# **K&T #14**

## **Inspection Overview, Observed Defects & Corrective Actions**

Jason Sobczynski  
Next Generation Rail Services

2) Flexible bolts installed via filet through torch cut holes which are between 1/8" to 5/8" oversized. This violates PL-30.4.4, and also PW-29.3.

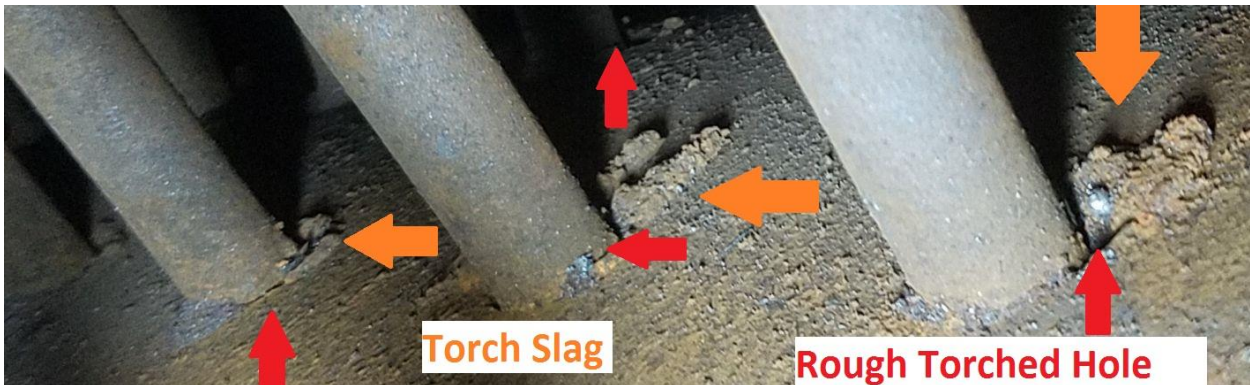
PW-29.3: The surfaces left behind (throughout the firebox) by the torch cutting are not free of torch scale or slag (foreign material), and are also notched and consistently textured with deep striations. This in turn violates CFR49 Part 230.29 (b) (1). Hundreds such locations exist.

**The above depicts holes well in excess of 1/8" oversize on fluesheet**

### **2) Flexible bolts installed via filet through torch cut holes which are between 1/8" to 5/8" oversized.**

Due to the incorrect method of installation, all flexible staybolts must be removed and replaced. In order to properly install new staybolts, the firebox sheets must also be replaced due to the oversized, and damaged holes.

**Orange denotes 2" diameter torch cut holes.**

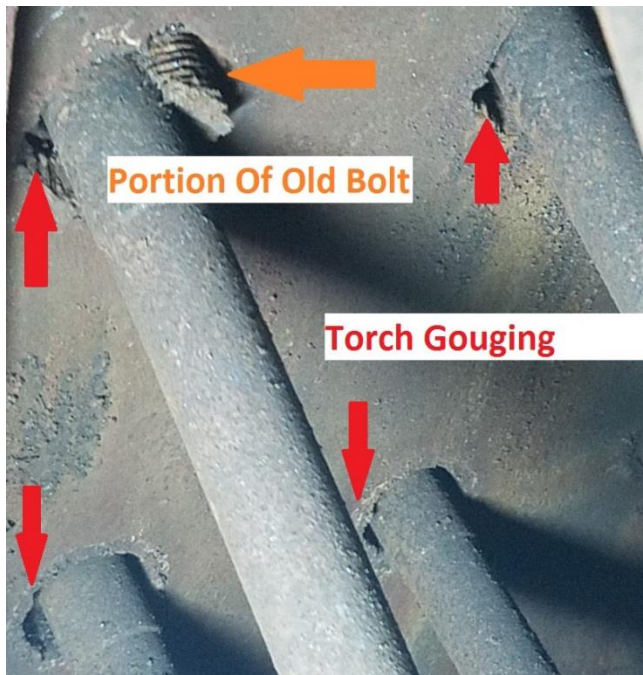
**Red denotes holes in excess of 1/4" oversize in FR crown sheet**

3) **All New Holes for flexible sleeves thermally enlarged. Torch scale, slag, gouges, and striations not removed prior to welding.**

In addition to the violations to code consistent with PW-29.3, the accompanying photos depict a portion of an original rigid bolt remaining alongside of (and partially consumed by) a rough cut hole. This in turn violates CFR49 Part 230.29 (b) (1). This boiler has approximately 300 flexible bolts.

### **3) Holes for flexible sleeves thermally enlarged. Torch scale, slag, gouges, and striations not removed prior to welding.**

Once all flexible bolts are removed, the accompanying sleeves will then need to be removed. This will facilitate reclaiming the holes in the external firebox sheets via welding following proper hole preparation.

Heavily Gouged Holes

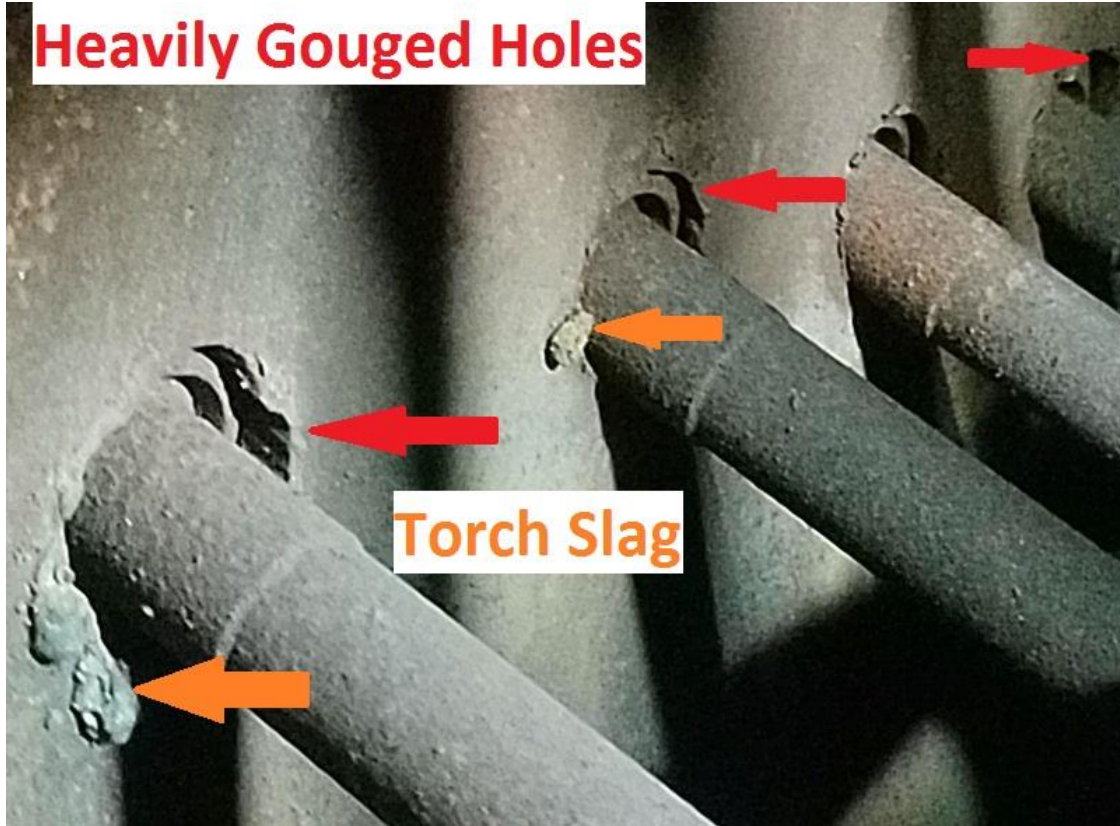
Torch Slag

## 5) Interior Firebox Corners, Plate Misalignment, Lack of Full Penetration Weld

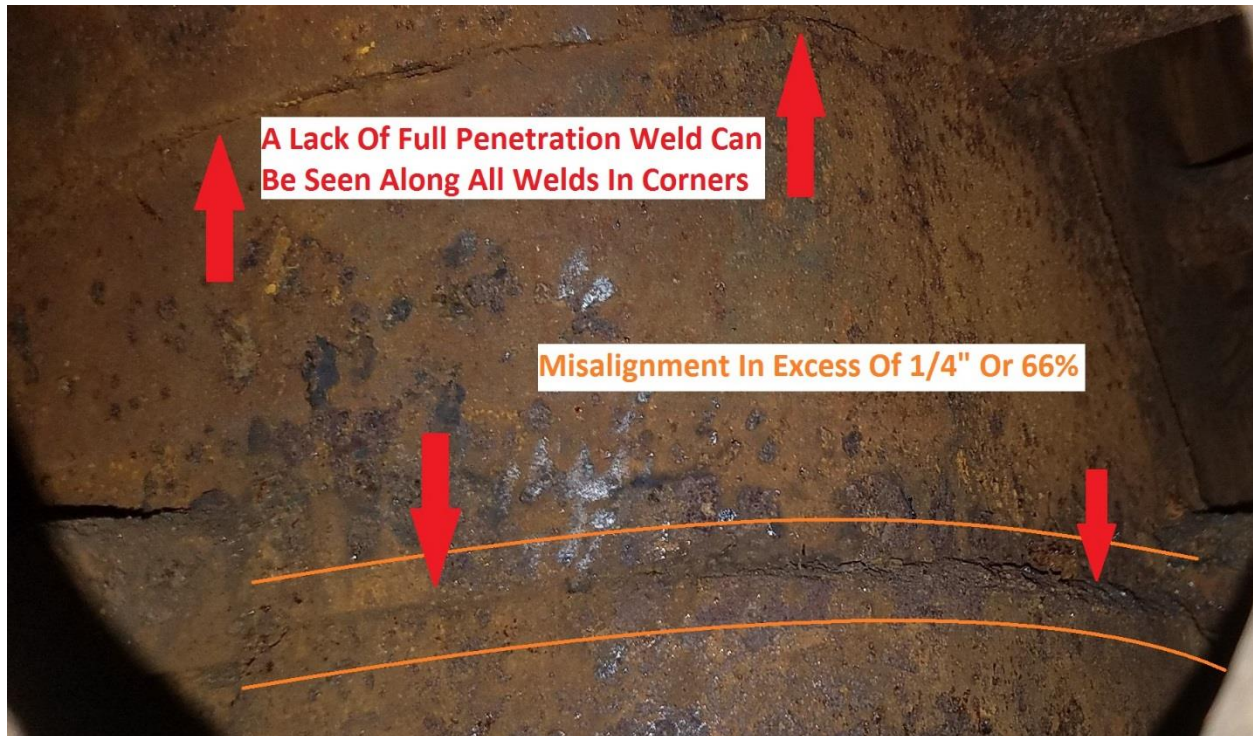
PW-9.3.1 lays out permissible tolerances associated with sheet misalignment, the maximum allowable is 25% of sheet thickness. Misalignment on the waterside of the sheet are up to 83% or 5/16". This in turn violates CFR49 Part 230.29 (b) (1).

PW-9.1. states that all welds are to be full penetration. It can be seen from the above photos that there is no 1 in 3 blending of the above limit offset, and no sign of weld coming through to the waterside of the plate. This in turn violates CFR49 Part 230.29 (b) (1).

### **5) Interior Firebox Corners, Plate Misalignment, Lack of Full Penetration Weld**

The defects associated with the corners require their replacement. This will be done in conjunction with items 1, 2, and 4.

## 6) A Portion Of The New Firebox Was Replaced With Flat Plate In A Tight Radius

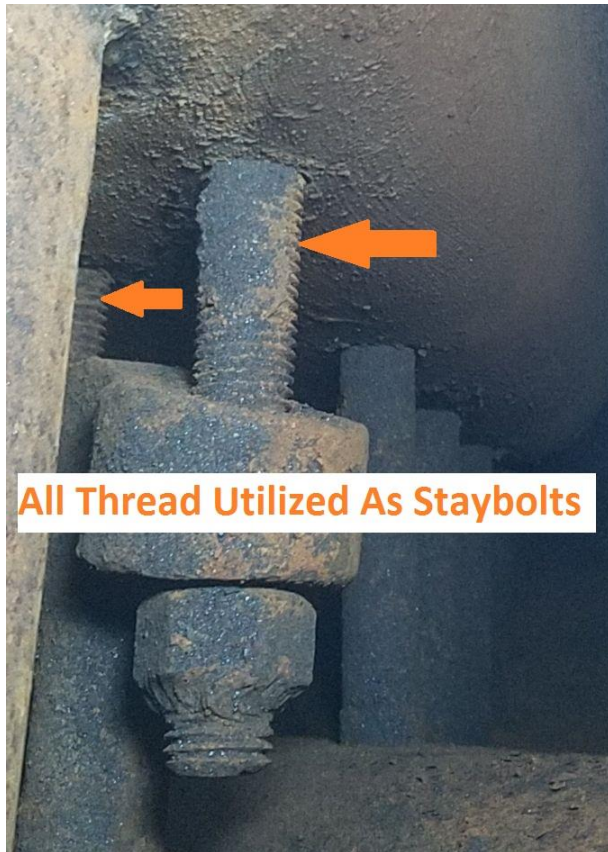
A sharply radiused portion of the new firebox was cut out and replaced with a piece of flat plate. This is contrary to O.E.M. design and violates railroad standard practice, and NBIC code. PW-9.3.1 states that the “middle lines” of the plate are to be aligned, these are not as one is radiused and the other straight. When replacing a portion of any boiler it is to be replaced “in kind” to the original. This in turn violates CFR49 Part 230.29 (b) (1).

### **6) A Portion Of The New Firebox Was Replaced With Flat Plate In A Tight Radius**

This defect requires the replacement of the flat plate with a piece of material formed to properly match the centerline of the adjoining plate. This will be corrected in conjunction with items 1, 2, and 3.

### 9) Bolts Welded Into The Vessel As Studs For Attachment Of Delivery Tee, Bolts Installed Through Torch Cut Holes

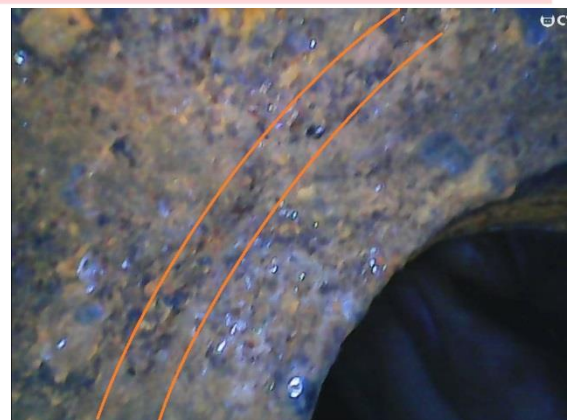
The issues with the bolts are no different than those of the studs, the use of bolts is not a compliant practice. The bolts are installed through torch cut holes, leaving behind gouging and striations. As discussed above, PW-29.3 prohibits these physical conditions. The integrity of the reinforcing ring has been compromised. This in turn violates CFR49 Part 230.29 (b) (1).

The reinforcing ring requires replacement to correct for the torch cut holes. Depending upon the appearance of the fluesheet once the non-code material is removed, a patch may be required.

## 11) Dome Studs Welded

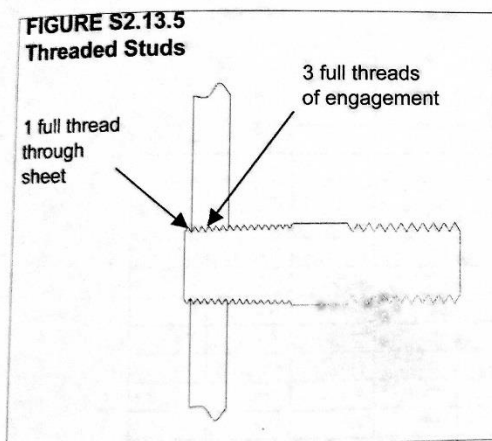
All of the dome studs have been seal welded in direct contradiction to NBIC Part 3 S2.13.5, the studs are no longer suitable for service. This in turn violates CFR49 Part 230.29 (b) (1).

All dome studs require replacement due to the seal welding.

#### 15) **Washout Plugs Of Incorrect Material, Holes Cross-Threaded**

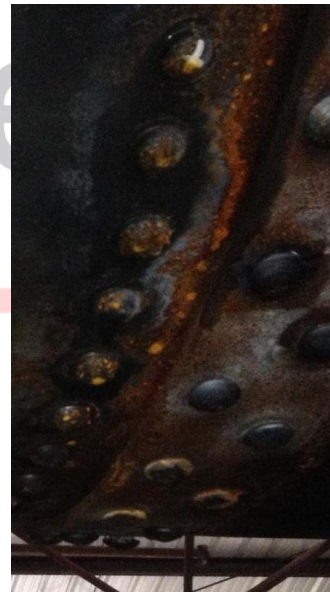
All washout plugs are machined from a steel material. It is a well-accepted fact that steel plugs will seize in their threaded hole when utilized in locomotive boiler service, standard practice dictates the use of SB-61 bronze. Several holes are severely cross threaded.

All cross-threaded holes will be re-threaded, and all plugs will be made new of SB-61/C922, code compliant, bronze material.
